P 526716  
 A 526272 - UPGRADE

**ON-SITE SEWAGE DISPOSAL SYSTEM  
 HOWARD COUNTY HEALTH DEPARTMENT  
 BUREAU OF ENVIRONMENTAL HEALTH**

ADDRESS: 575 Morgan Station Road PROPERTY OWNER: Drew Powers

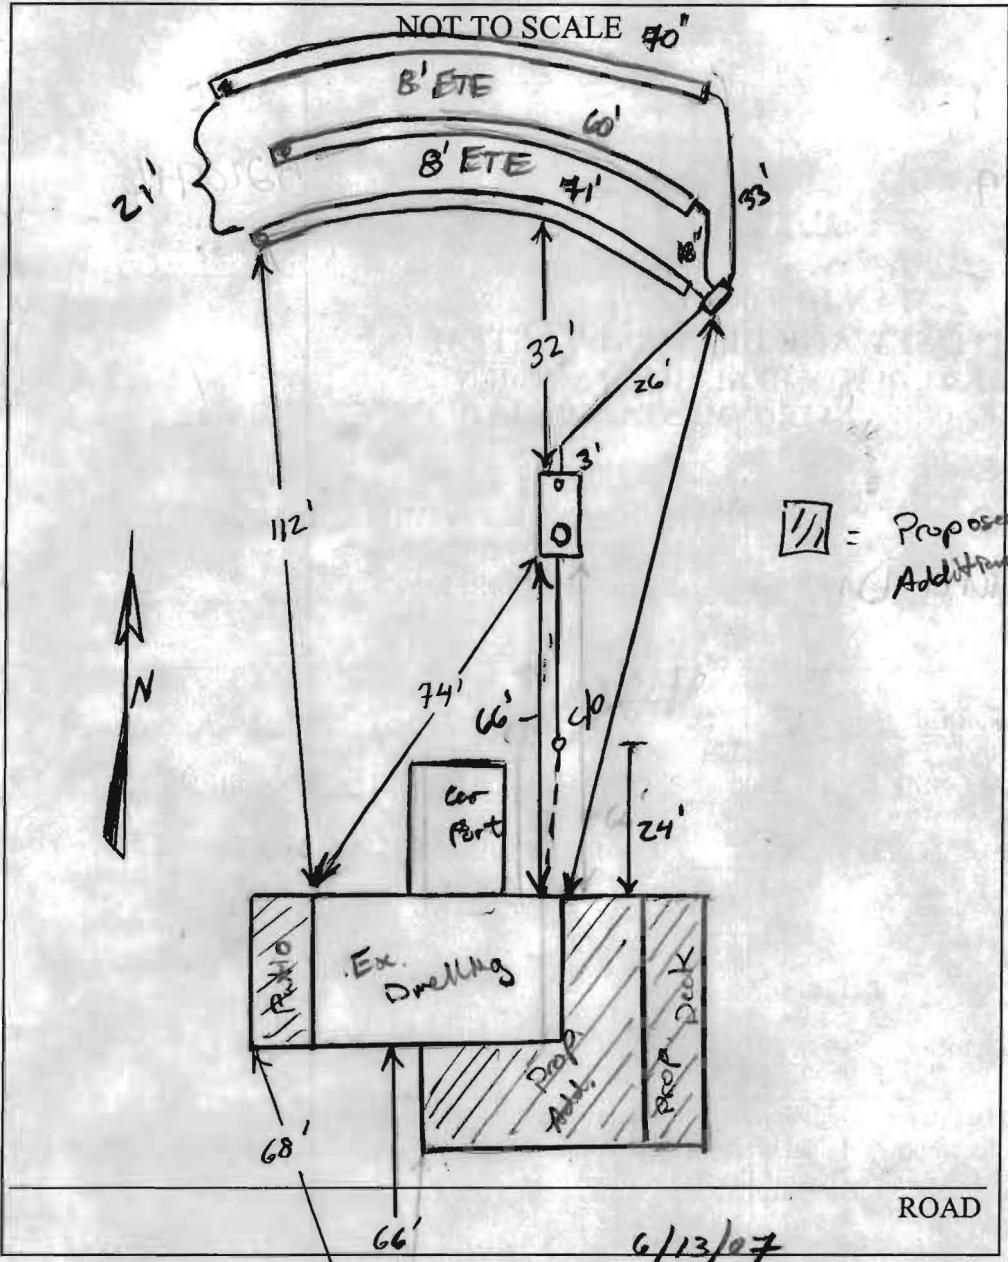
Septic Area. Could not verify (in field), ex. perc holes near. Needs to be staked. Tank LOC. to be determined

after SRA is staked. Call Health Dept. for layout insp. 7/24/07 OK to set tank 55' from house to stay clear of prop Drive and to maximize cover on tank. Clear wooded area @ top of SRA. Layout to be given when cleared. (KW) 7/25/07 Tank set. need to keep no more than 3.5' of cover on tank. 7/26/07 System complete

Need baffle in inlet/tank. Finish up w/ last trench call for final insp. (KW) 7/27/07 Sys. complete, Need correct install

Mr. Way DATE OF APPROVAL 7/27/07 for obs. ppe @ end of bottom trench. OK to Backfill (KW)
